CERTIFICATE OF APPROPRIATENESS

Property: 2611 Hopkins Street, Lot 9, Block 2, Montrose. The property includes a two-story single-family residence and a detached one-story garage on a 6,500 square foot (65' x 100') interior lot.

Proposal: Alteration – Addition

PROPOSED RIGHT ELEVATION – CLOSE UP

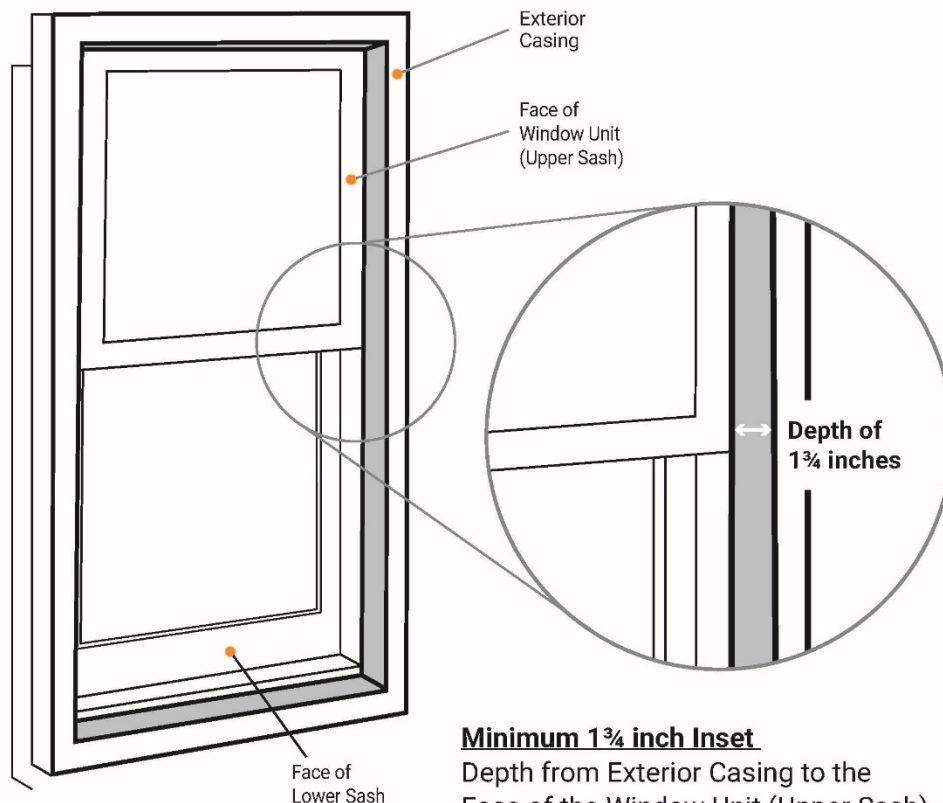
Recommendation: Approval with conditions: that the proposed windows being installed on the right elevation be wood, wood clad, or wood composite.

Both windows are proposed to be removed with vinyl.

Please note Sec. 33-237 (2): An alteration is obscured from view from the street by the original structure and **not merely obscured by** fencing, **landscaping**, non-historic additions, or other impermanent obstructions.
